**ADDENDUM NO. 1
TO THE
SPECIFICATIONS, PROPOSAL, AND CONTRACT DOCUMENTS**

**TOTEM LAKE CONNECTOR BRIDGE
JOB # 01-20-PW/NMC0861000**

CITY OF KIRKLAND, WASHINGTON

CITY OF KIRKLAND
TOTEM LAKE CONNECTION
**SUPERSTRUCTURE
END BEAM DETAILS - SHEET 1**
Addendum No. 1 - Page 10 of 16

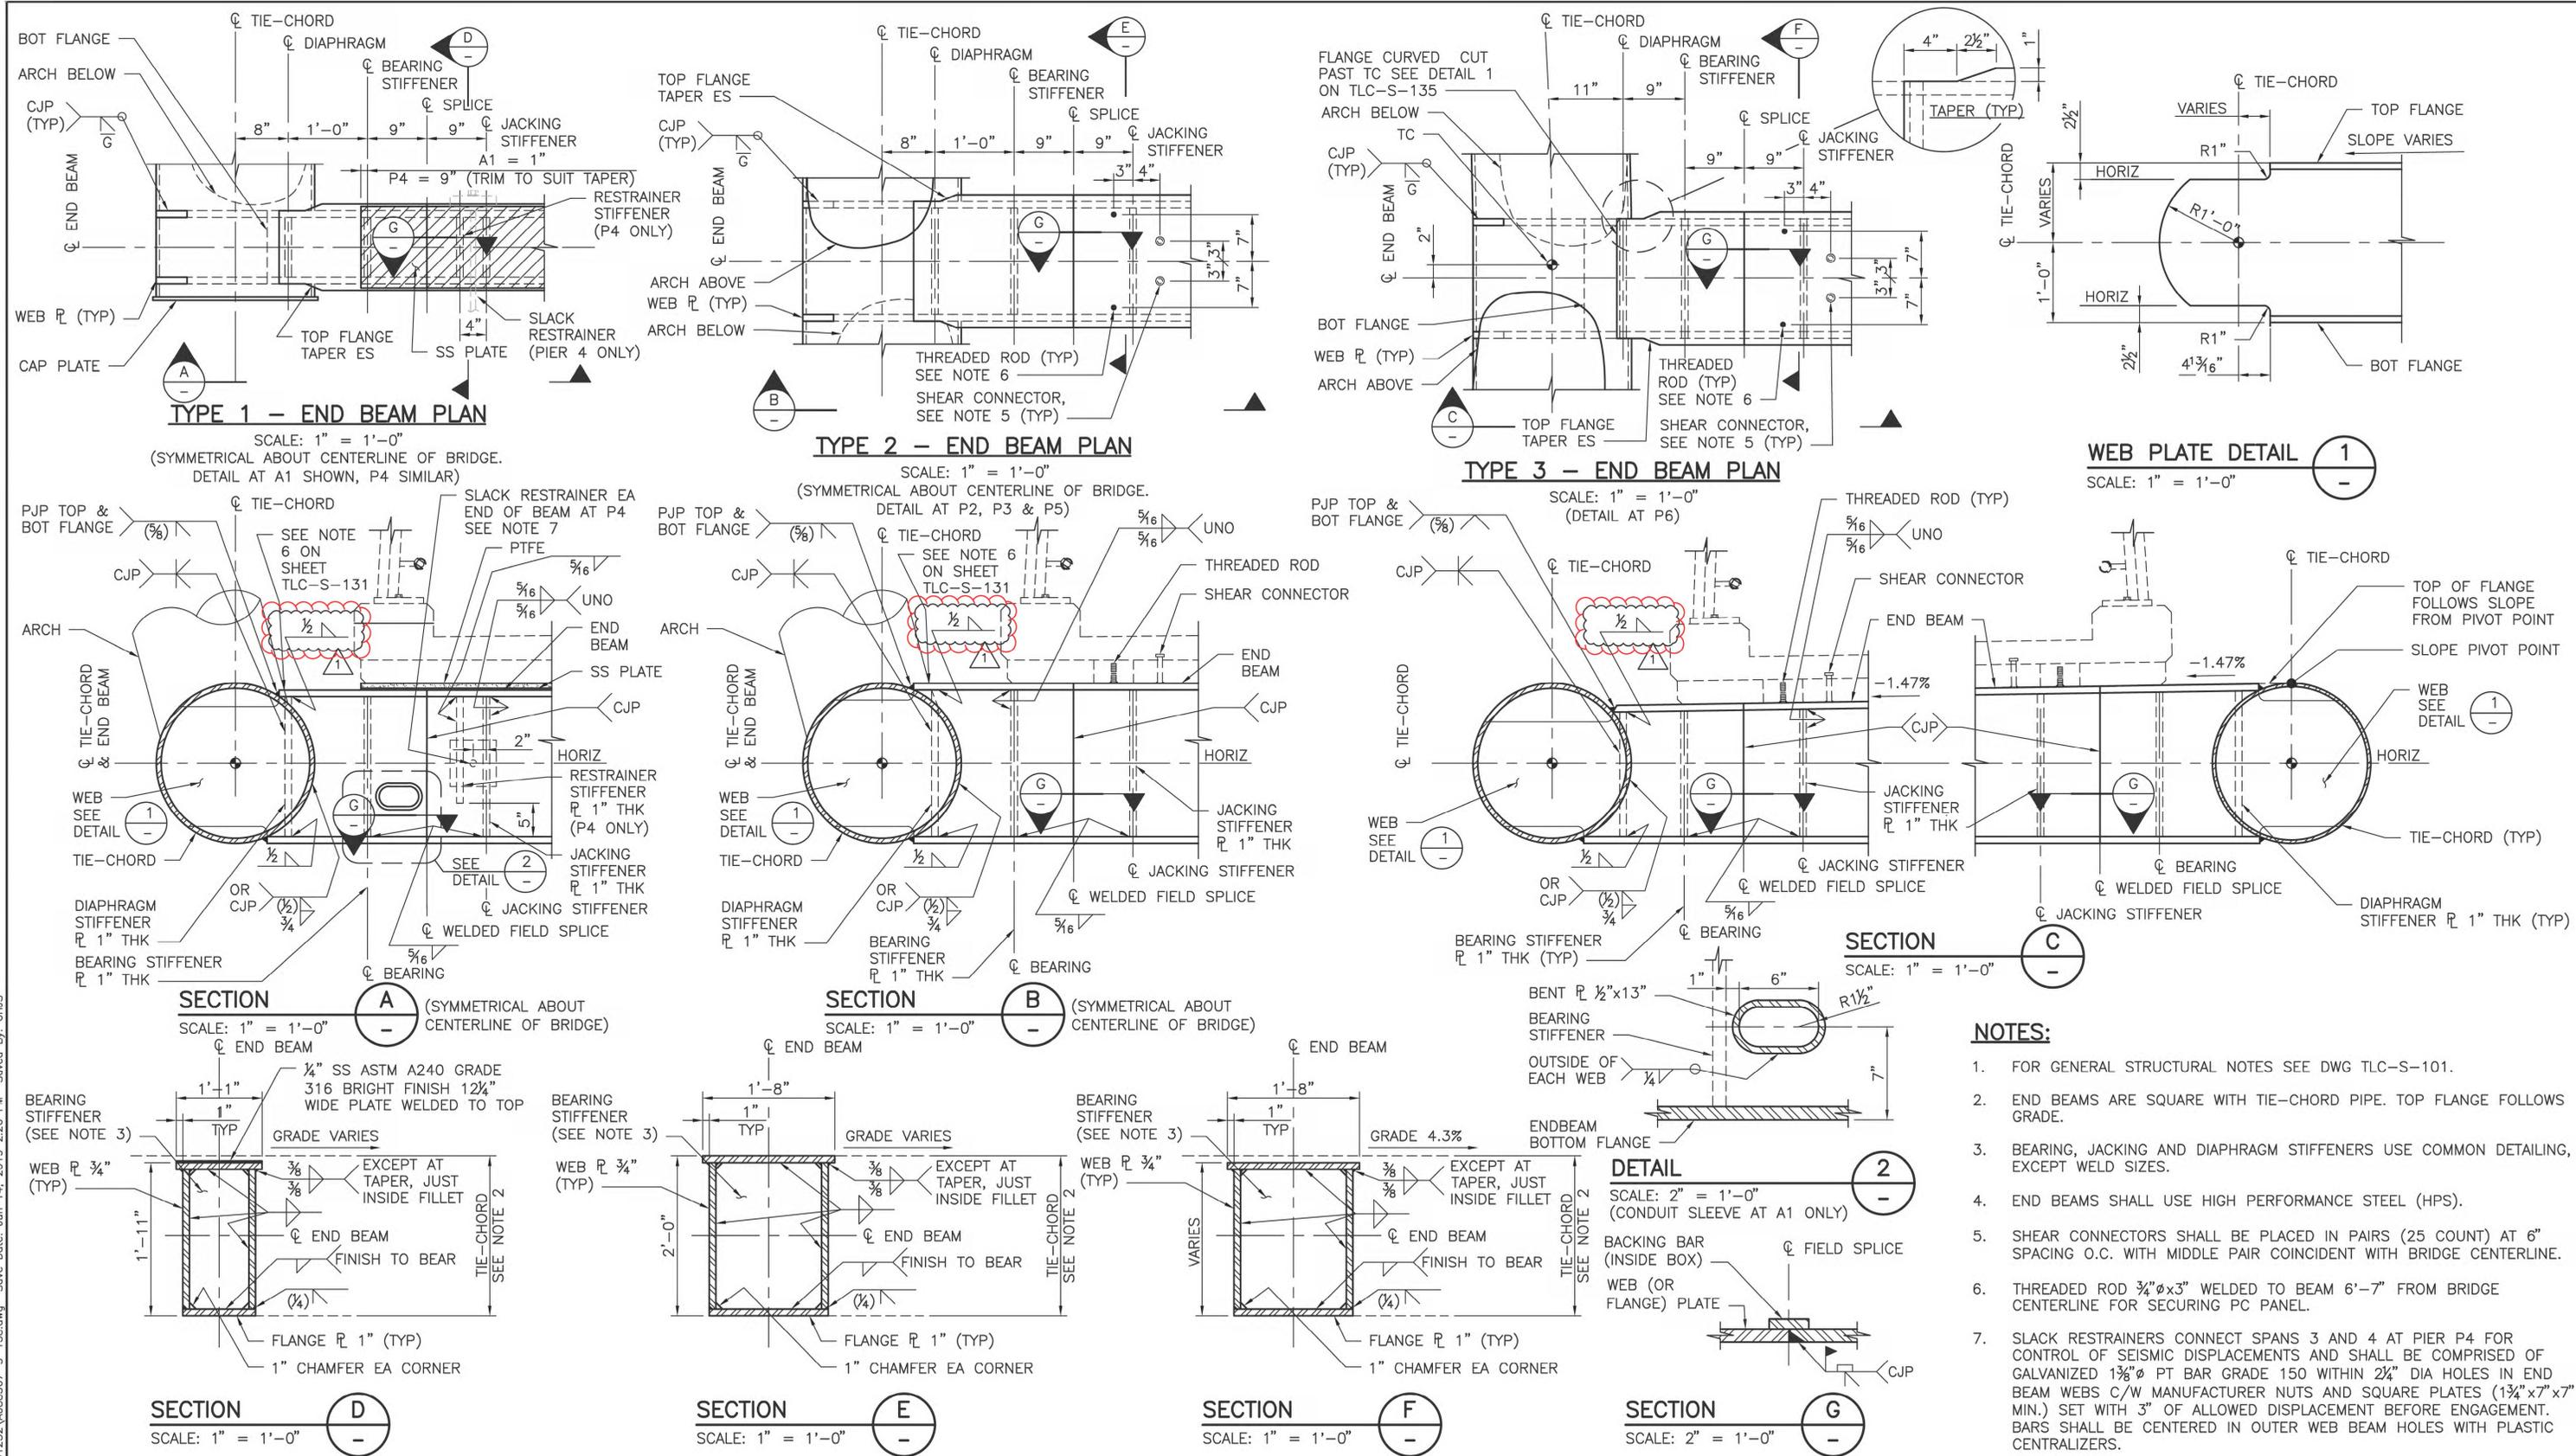
ITEM NO. 4: Plan Sheet TLC-S-138 Replacement

Replace plan sheet TLC-S-138 dated 12/06/2019 (Issued for Bid) with this plan sheet TLC-S-138 Rev.1 dated 2/11/2020.

Reason for replacement: Sections A, B and C have been modified as indicated by **red outlines** shown.
